WATER BOARD UPDATE FOR SEPTEMBER 29 1992

SUBJECT: Cape Dorset -Design brief for water supply improvements
in the community: comments and recommendations

5.2 Recommendations

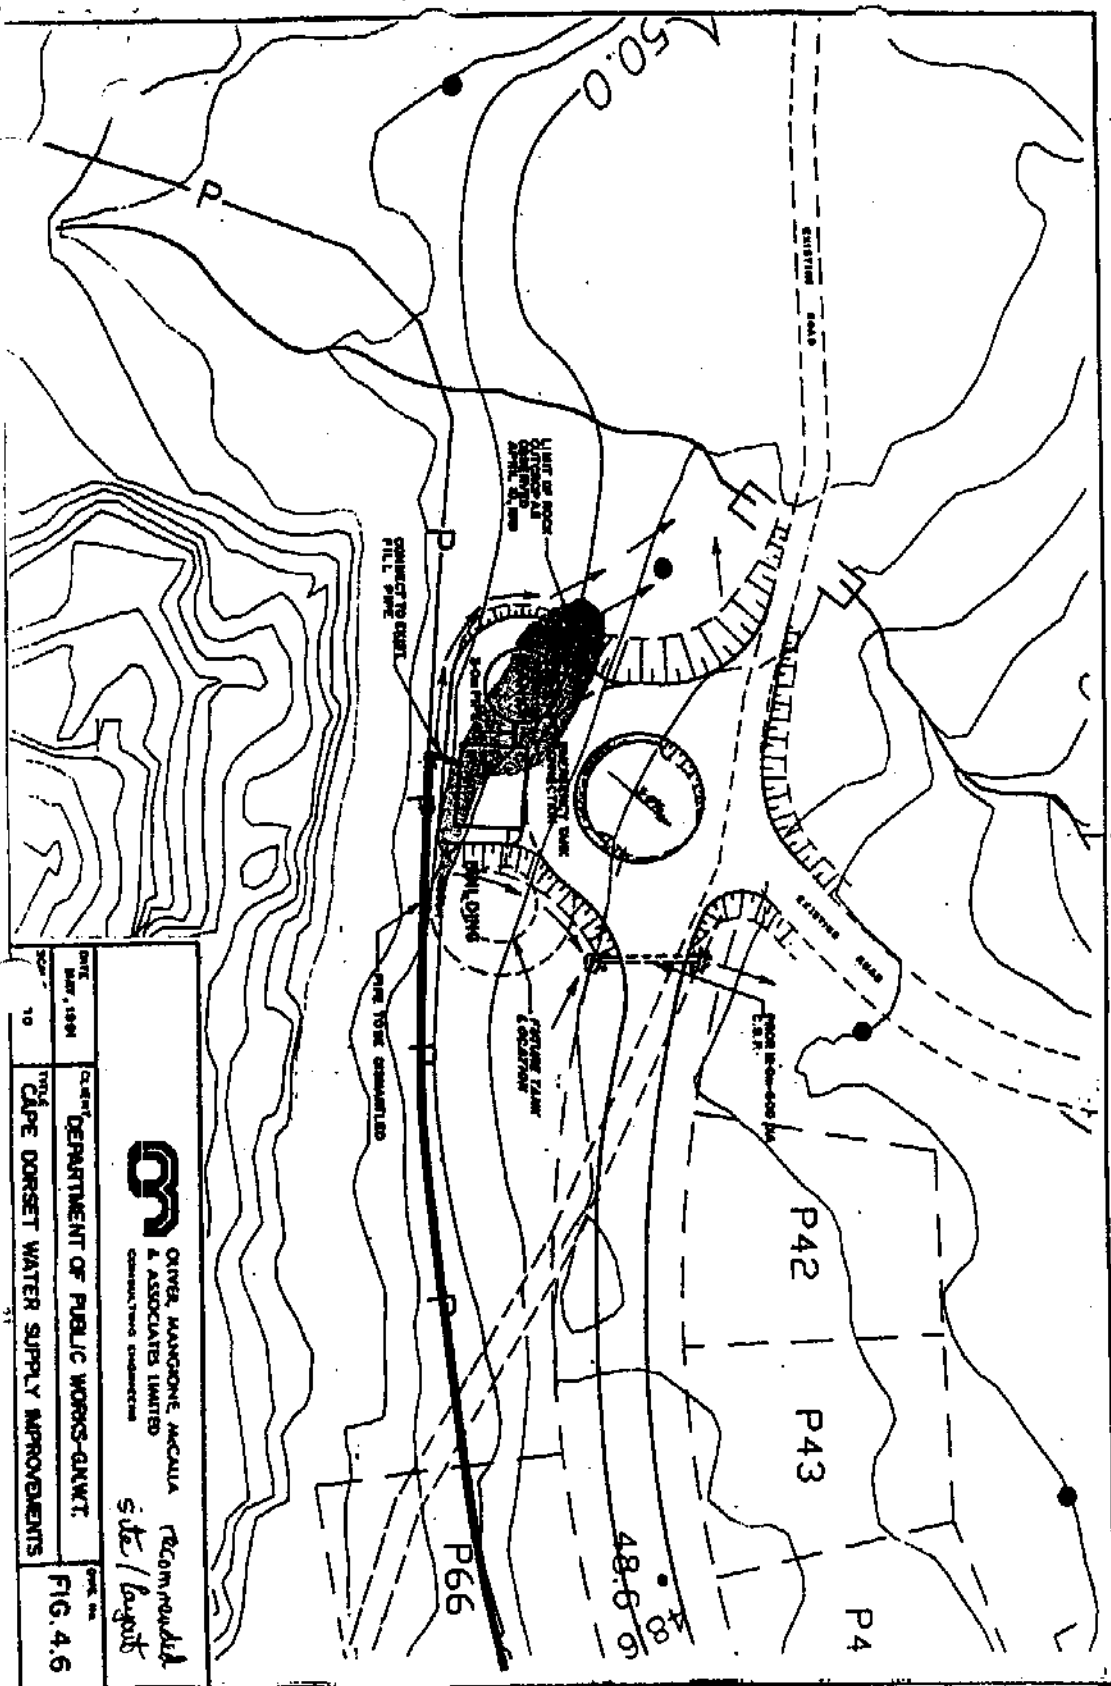
STATUS: good question. As with similar reports being provided for other projects, no clarification is provided as to what final option and /or recommendations were chosen. This report is 17 months old. For example, recommendation 3 (attached) alludes to site works being constructed in 1991..were they ?
A quick scan of this report did not reveal any major concerns from my perspective, but others with more familiarity with municipal matters might.

RECOMMENDATIONS: Get clarification from MACA and NAP district office as to current plans and status of any new facilities built or under construction. Facilities should be built to accommodate future growth, something not discussed in the reports.
-send the reports and any updated information to TAC for comment.
-send an acknowledgement letter from the Water Board to MACA, noting that the reports will be reviewed, or if inadequate information is obtained re current planned facilities, to please provide it .
-File correspondence from NAP Baffin district to Water Resources in 1991 suggested "some form of parallel activity" be considered if/when licensing of Cape Dorset, Clyde River, and Pond Inlet is considered.
-MACA could also be reminded at this point that licensing will require prior environmental screening, and to include such considerations in final site selection and construction- if not already undertaken.
